Stream Flow Monitoring Report - Water Year 2019 – Salmon Creek

*Annex Creek/Salmon Creek Hydroelectric Project
(FERC Project No. 2307)*

**Alaska Electric Light and Power Company
Juneau, Alaska**

December 2, 2019

Figure 2 – Fourth Quarter 2018 Corrected Discharge

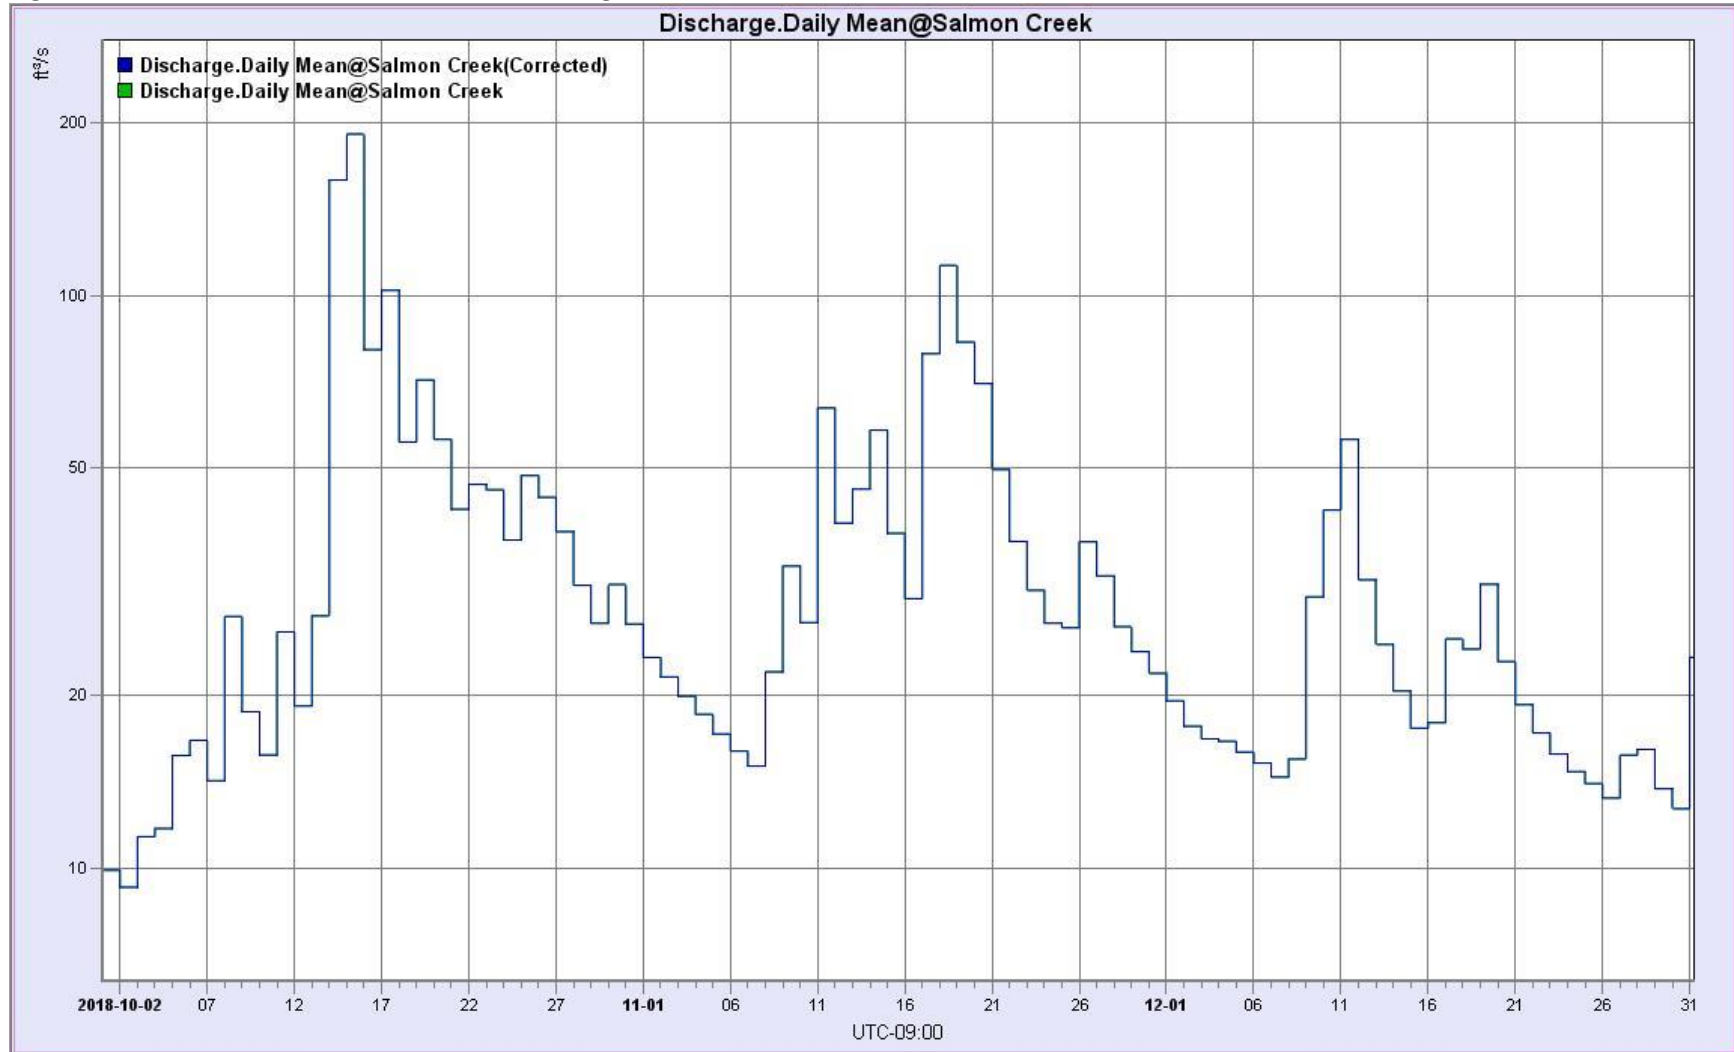
- 1) Figure 2 is labeled as the "Fourth Quarter 2018 Corrected Discharge" but the data is the data from the Third quarter (i.e. a repeat of Figure 1). Please replace this with the graph for the Fourth Quarter.

ADF&G provided comments which showed that Figure 2 needed to be updated, a corrected Figure 2 has been included in this final draft. The comments also questioned the arrows showing supplemental valve operation on 8/17/19. The valve was closed at 8:03am and then reopened later that same day. During the day 0.92" of rain was recorded at the Juneau International Airport, so there was a short increase of streamflow during that period. The arrows in Figure D5 have been updated to reflect operation of the valve. The last comment was regarding communications failures to the site, more information on what AEL&P is doing to improve communications has been included in the body of the report.

Figure D5 – Third Quarter 2019

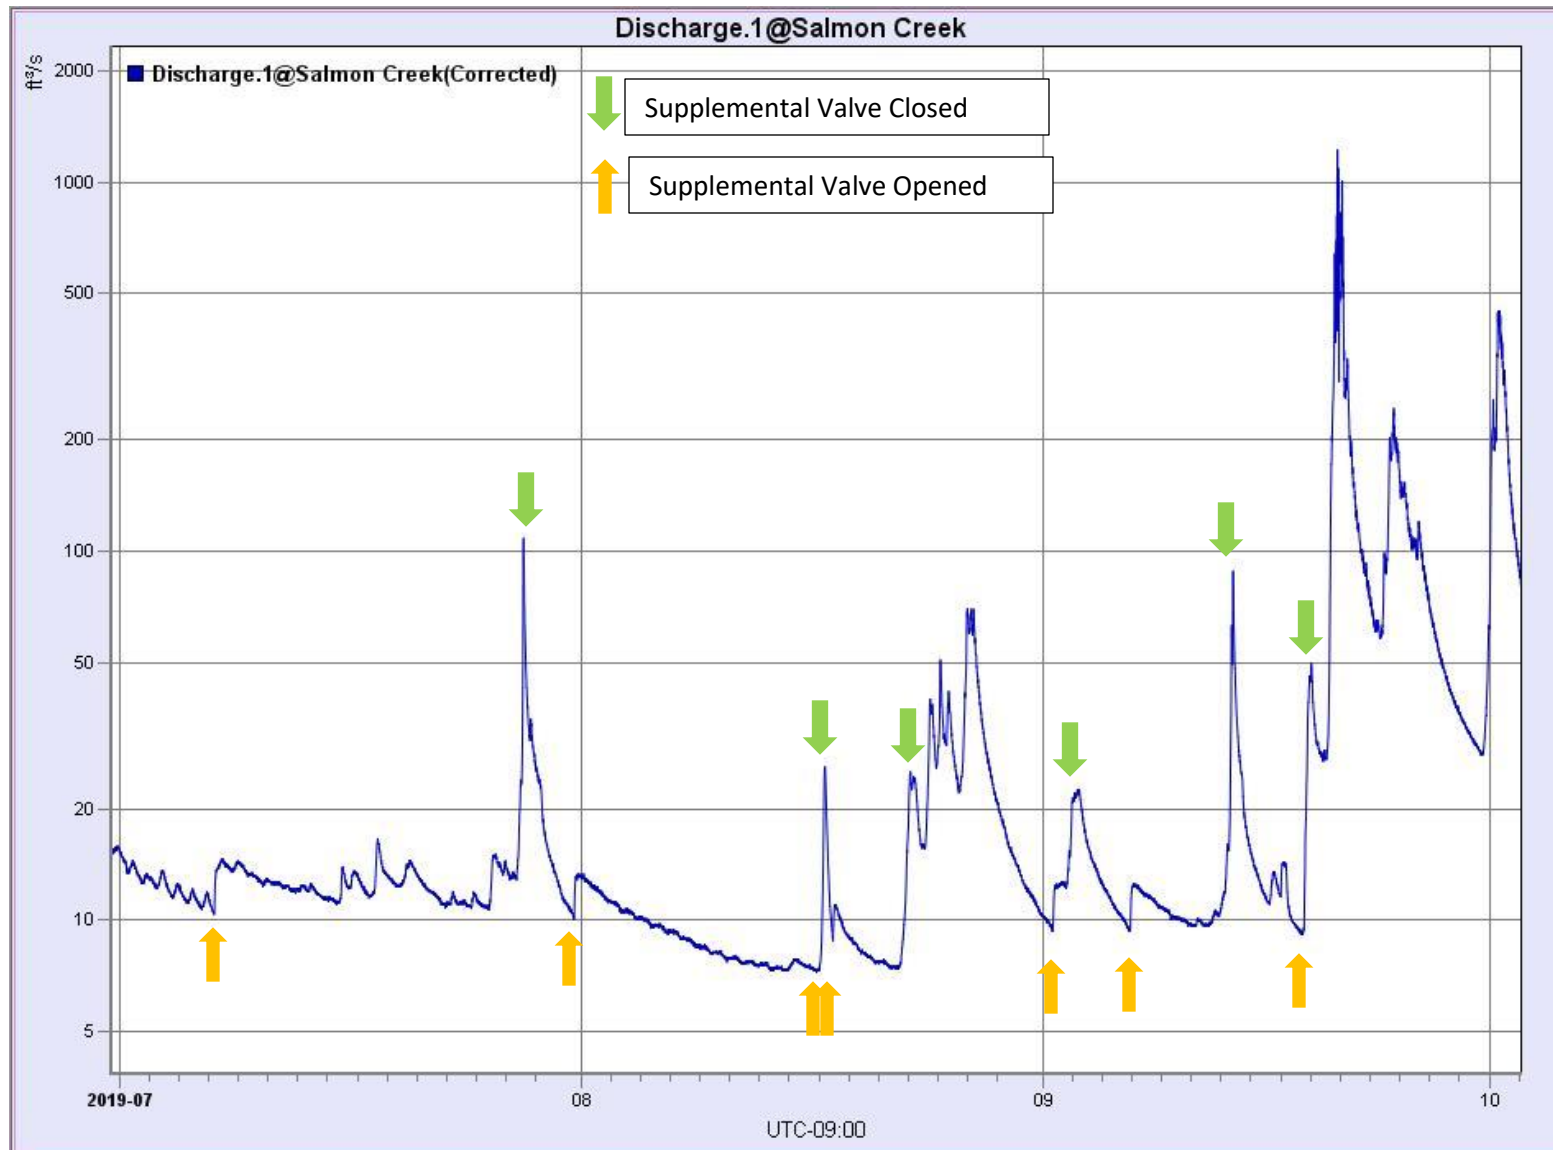
- 2) Figure D5 has a yellow arrow (indicating that the supplemental valve was opened) on August 20th, but the hydrograph and the Table in Section 1.3 both indicate that the valve was opened on August 17th, not the 20th. If that is indeed the case, please correct Figure D5.
